HISTORIC AND DESIGN REVIEW COMMISSION

November 02, 2022

HDRC CASE NO: 2022-399
ADDRESS: 363 NORTH DR
LEGAL DESCRIPTION: NCB 7026 BLK 5 LOT 16, E11 FT OF 18
ZONING: R-6, H
CITY COUNCIL DIST.: 7
DISTRICT: Monticello Park Historic District
APPLICANT: Thomas Gandy/GANDY THOMAS R
OWNER: Thomas Gandy/GANDY THOMAS R
TYPE OF WORK: Exterior modifications, fenestration modifications
APPLICATION RECEIVED: July 24, 2022
60-DAY REVIEW: Not applicable due to City Council Emergency Orders
CASE MANAGER: Edward Hall

1941 SANBORN MAP

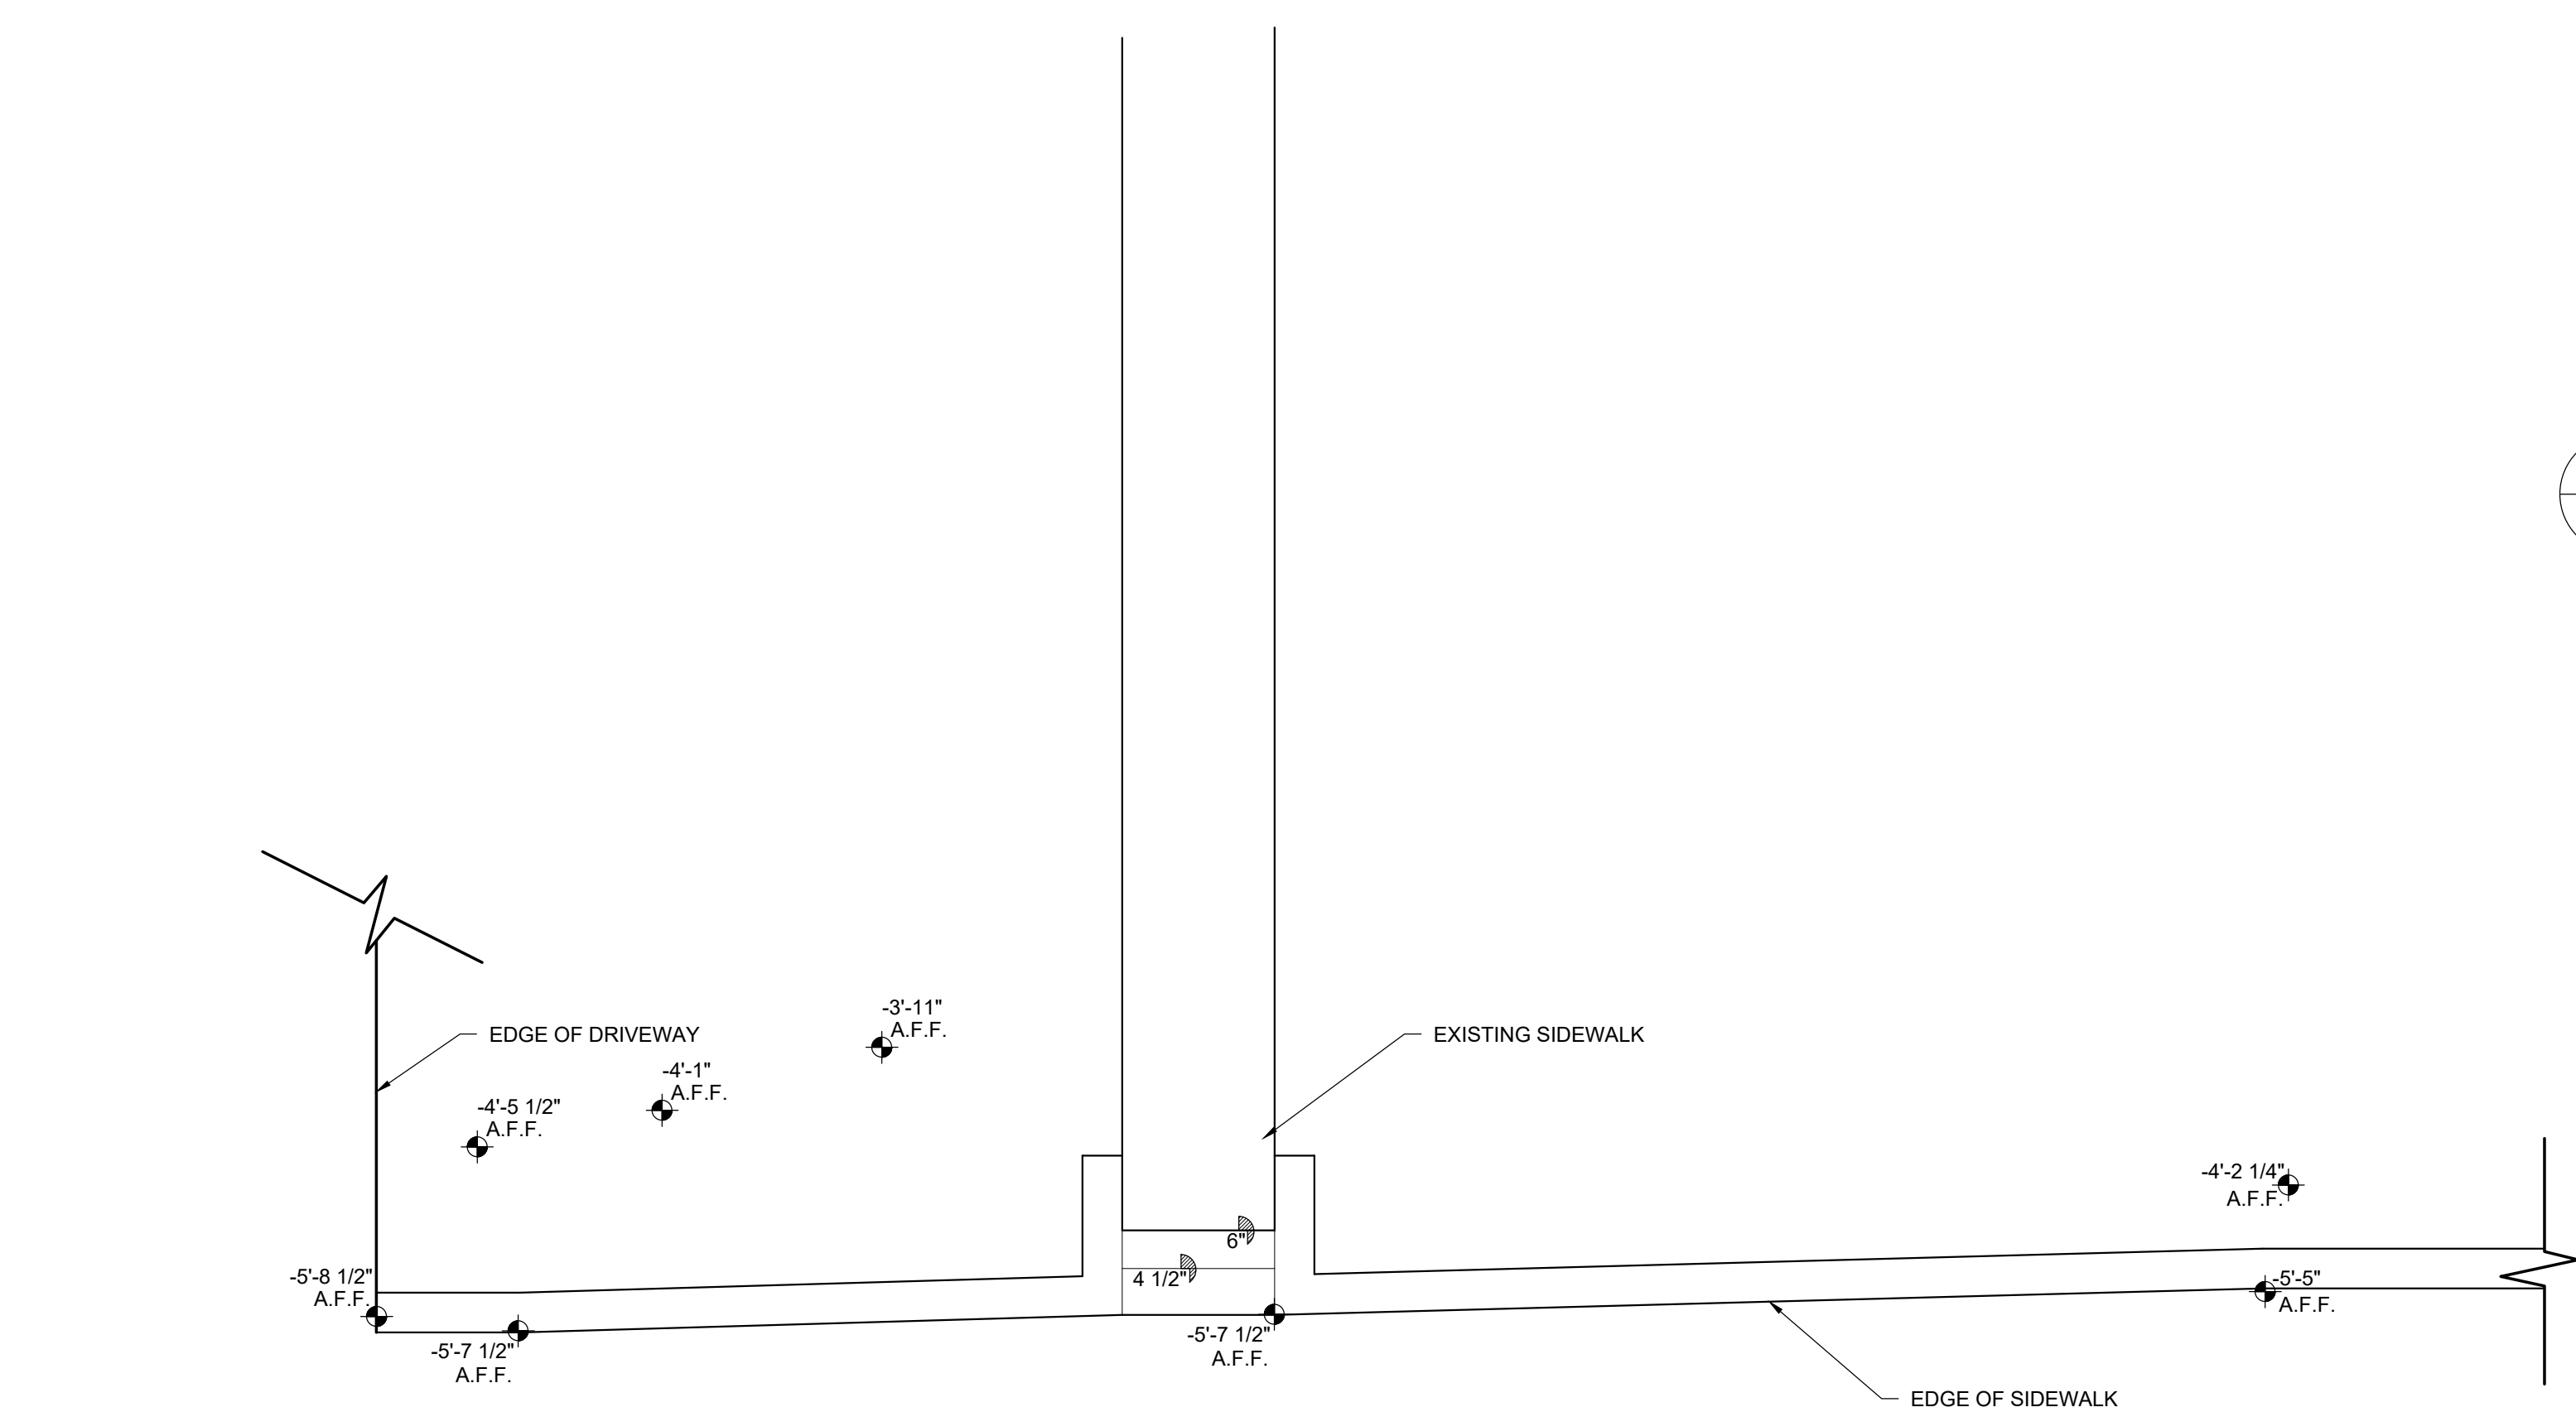
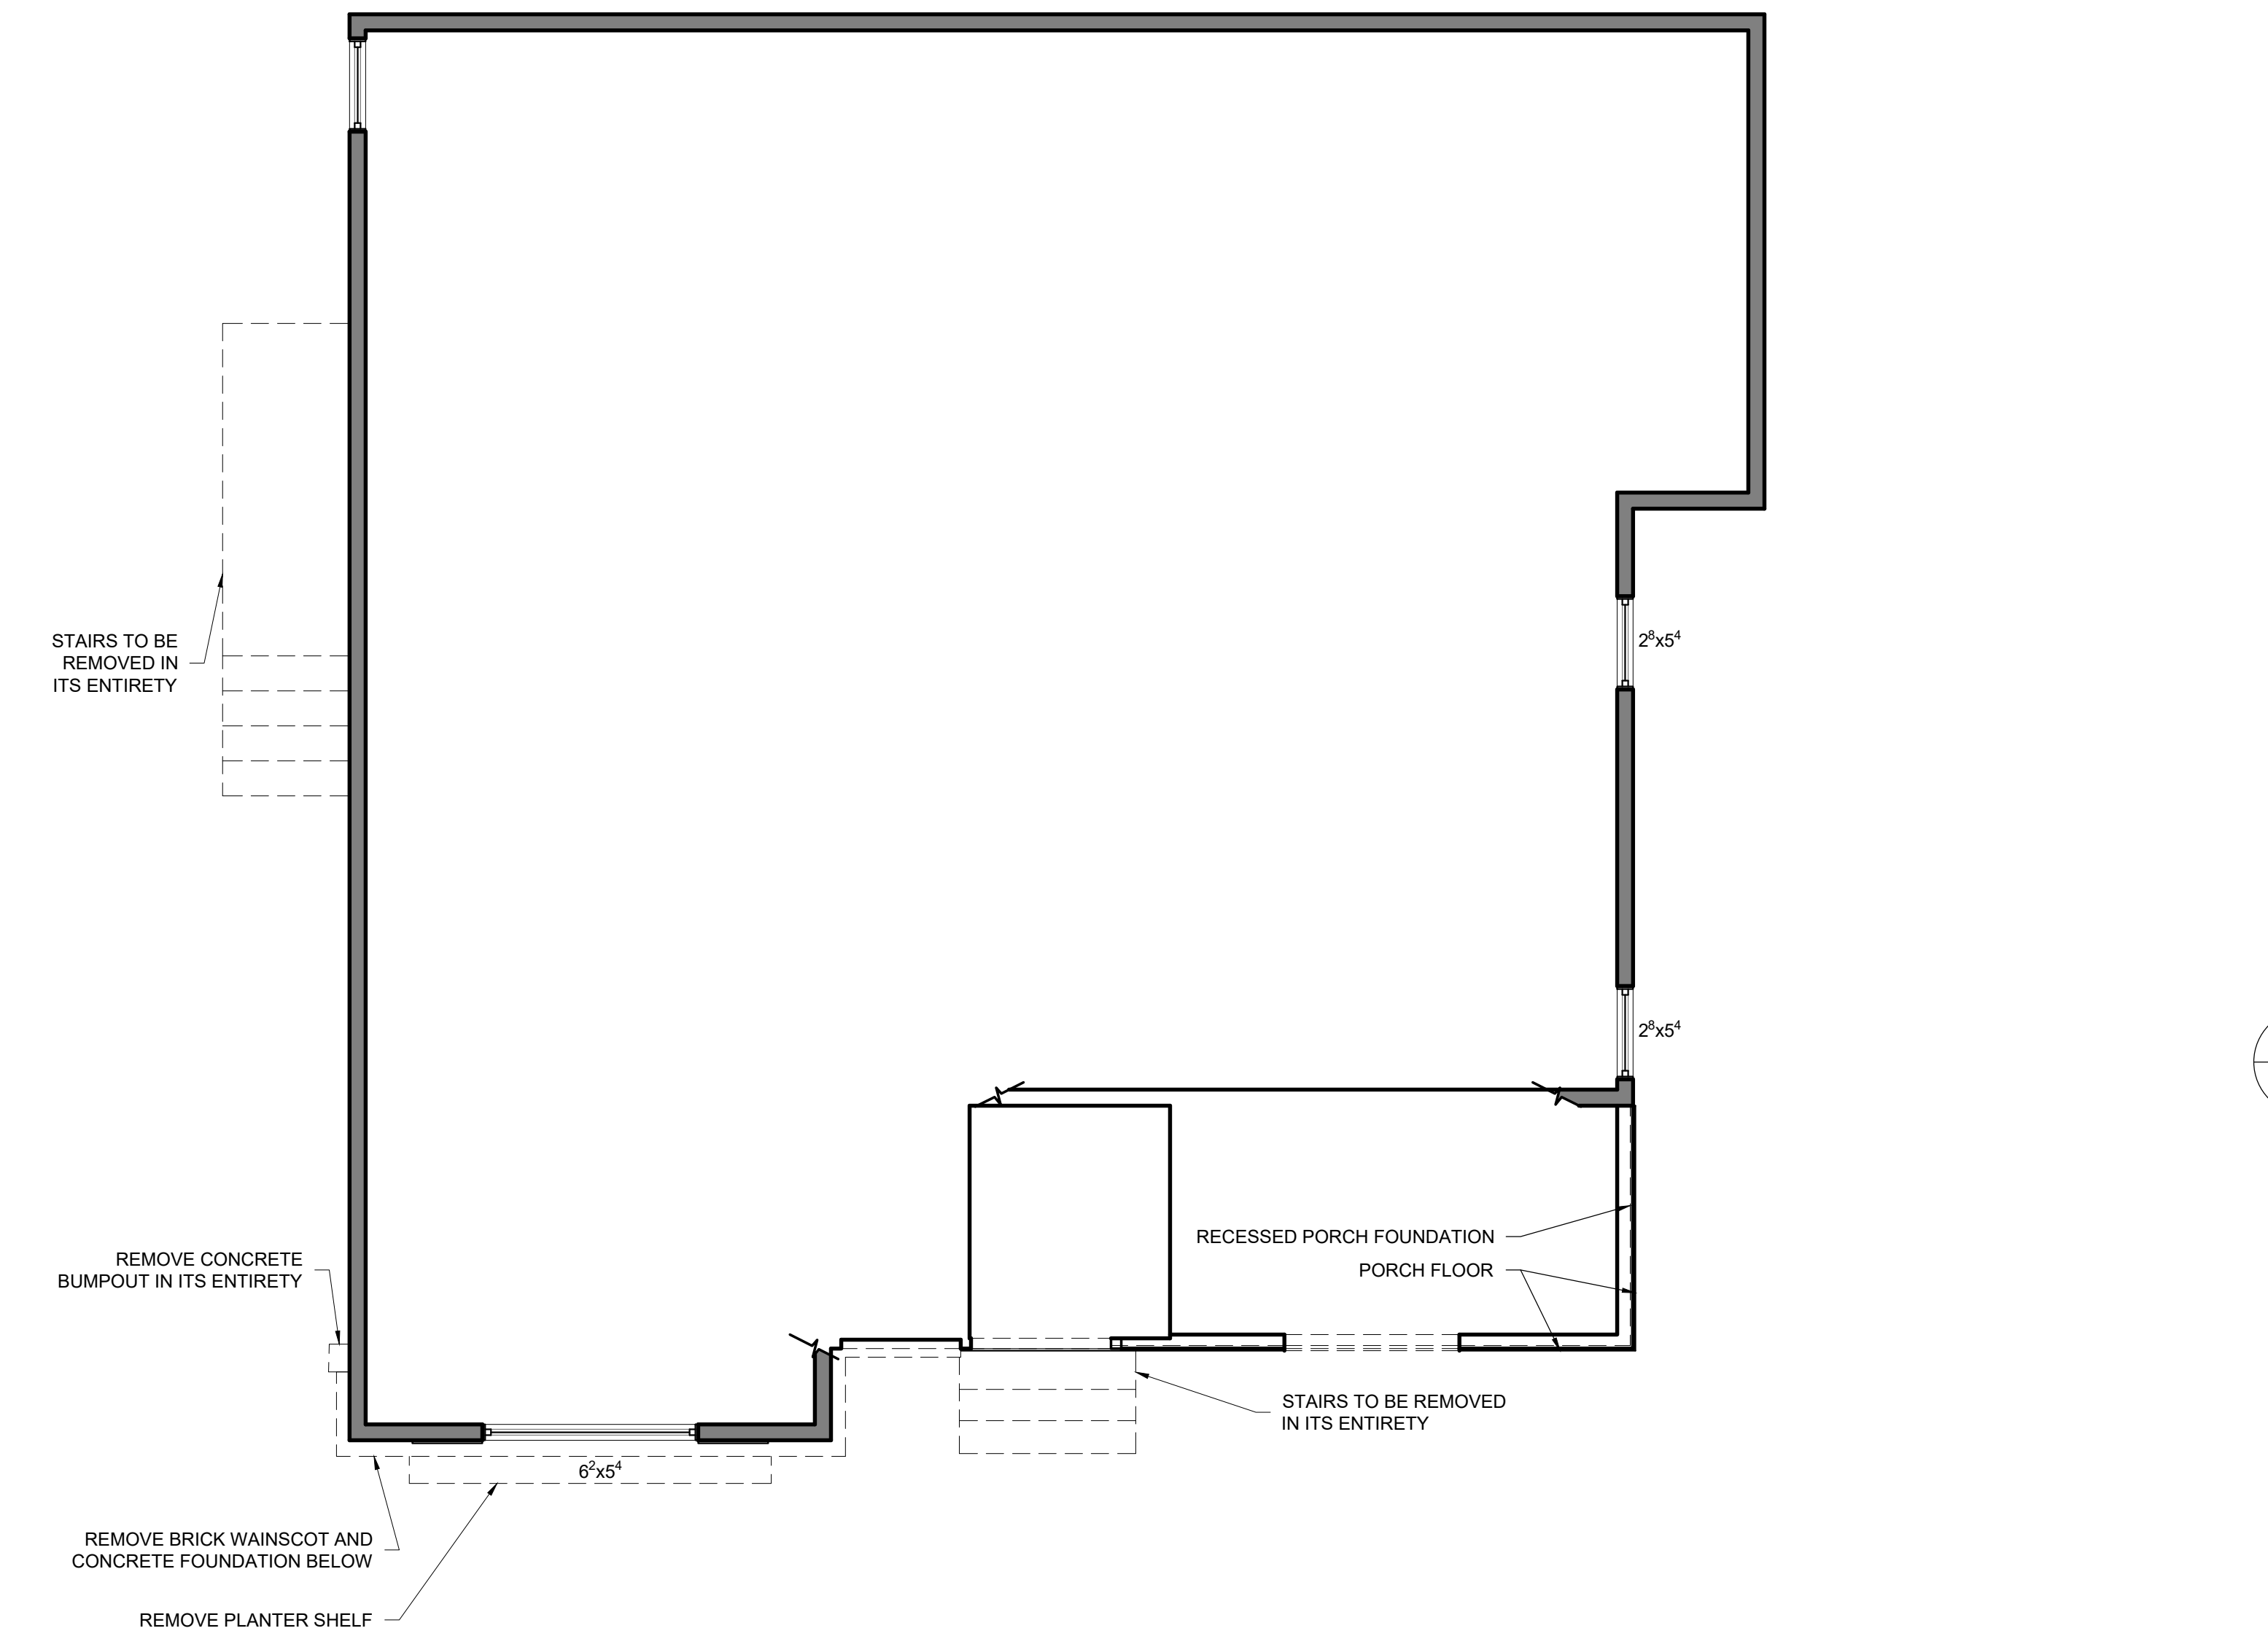
- e. SIDING INSTALLATION – The applicant has proposed to remove the existing façade tiles and brick wainscoting and install horizontal lap siding on each façade. Per the 1941 Sanborn Map, the structure originally features asbestos tiles. Staff finds the removal of asbestos tiles to be appropriate; however, a replacement tile should be installed that preserved the existing profile and appearance of the tiles siding. Many structures of similar form and style found on this block feature masonry (brick or stone) wainscoting. Staff finds the brick wainscoting to be original and finds that it should be preserved.

1. Staff does not recommend approval of item #1, the removal of the existing façade tiles and brick wainscoting for the installation of lap siding as noted in finding e. Staff recommends that the existing siding tile profile be maintained. Replacement with a fiber cement tile with matching profile would be appropriate and eligible for administrative approval.
